## Product Change Notice (PCN)

**Subject:** Assembly and sorting factory addition for RL78/I1C

Assembly and sorting factory addition for RL78/I1C 64pin,80pin,100pin LFQFP products.  
And Renesas Logo is additionally marked on the products of the additional factory.

PLQP0064KB-C

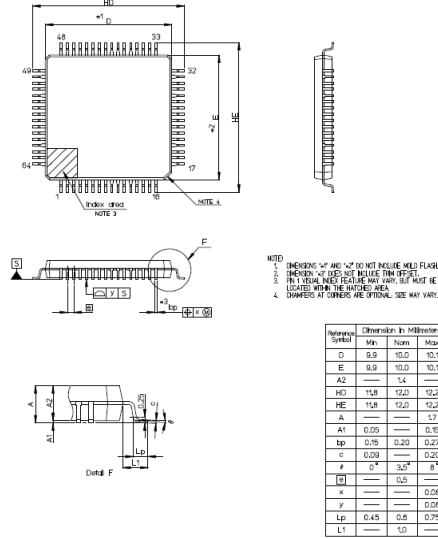
No	Item	Additional	Existing				
			KL/ KL	ASEKH/ BJ	ASEKH/ KYEC	Greatek/ KYEC	BJ/ BJ
1	Assembly / sorting factory	CG SEMI/ CG SEMI	KL/ KL	ASEKH/ BJ	ASEKH/ KYEC	Greatek/ KYEC	BJ/ BJ
2	Package outline	There are differences (Refer to pp.4-6 for detail)					
3	Wire	No change: Cu (Pd coating)					
4	Lead frame	There are differences (Refer to p.7 for detail)					
5	Marking	There are differences (Refer to pp.7-8 for detail)

Package Outline: Please refer to pp.4-6.
